GOVERNMENT OF THE DISTRICT OF COLUMBIA
DEPARTMENT OF TRANSPORTATION

MEMORANDUM

SUBJECT: ZC Case No. 13-05 – Forest City Washington - DC Water Occupied Sites

Figure 1- Proposed Site Access (Source: Grove/Slade)

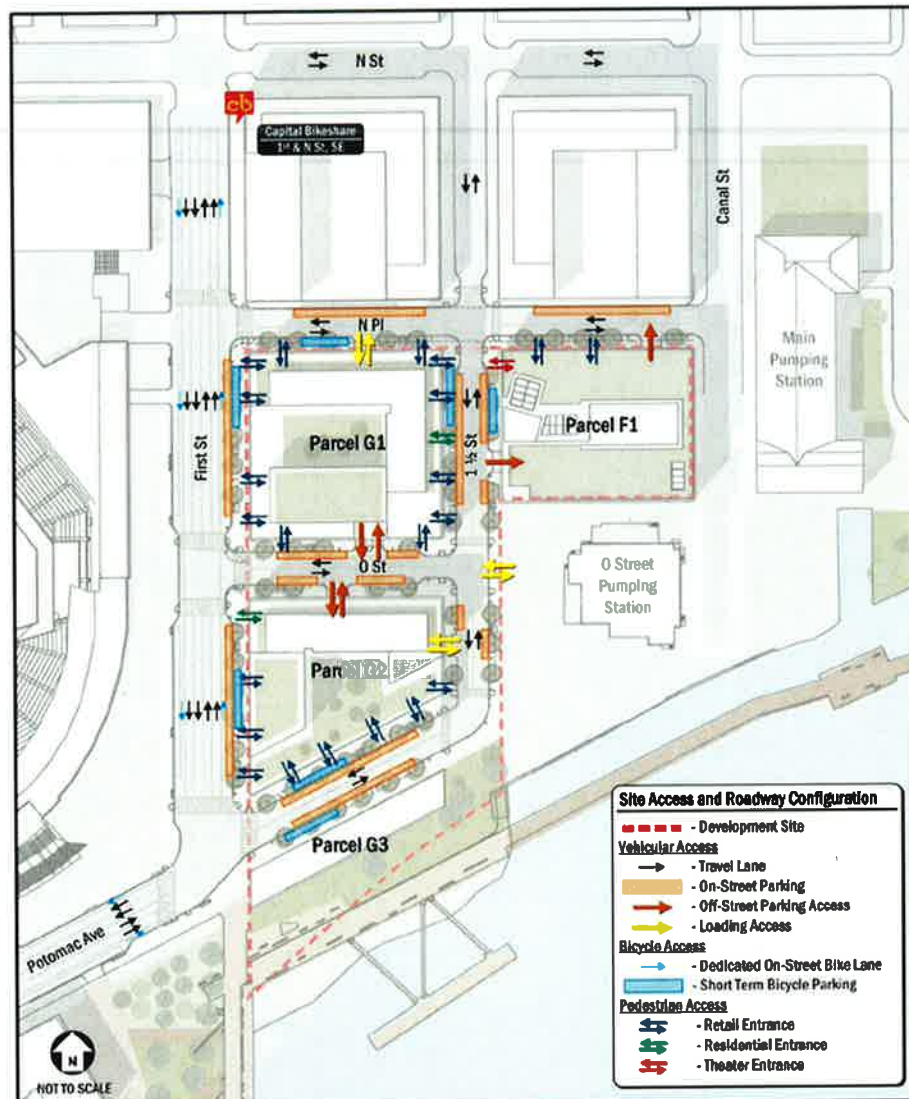
With the extension of Potomac Avenue, DDOT will require that the Applicant redesign the intersection of Potomac Avenue and 1st Street to reduce lane configuration offset and update the signal to accommodate new movements. The Applicant will also need to submit appropriate updated signal timing plans, lane marking plans, and may be subject to replacing the entire signal as deemed necessary by DDOT at the time of public space permitting. Additionally, the proposed curb-cut on N Place that would serve the movie theater is less than 60' from the future intersection with Canal Street. Per DDOT standards, no driveway entrance or exit on any roadway shall be closer than 60 ft. to a roadway intersection. DDOT will work with the Applicant on the design and location of this curb-cut to comply with current standards. Figure 1 provides an illustration of the proposed vehicle access plan for the PUD.

- Redesign intersection of Potomac Avenue and 1st Street to reduce lane configuration offset, and commit to cover all cost related to design and construction of appropriate new signal hardware.
- Relocate the driveway for Parcel F1 on N Place to accommodate safe spacing between the site driveway and the future extension of Canal Street.
- Prohibit subleasing of commercial spaces to adjacent businesses or residents.
- Provision to provide an onsite facility with showers and lockers for employees of the cinema and retail development.
- Exclude the approximately 100 Phase II retail parking spaces included in the Phase I parking garage or incorporate significant performance monitoring that could lead to the construction of a traffic signal at 1st and N Place if certain thresholds are not met.
- Provide an updated CTR for any portion of the PUD submitted for phase II approval.
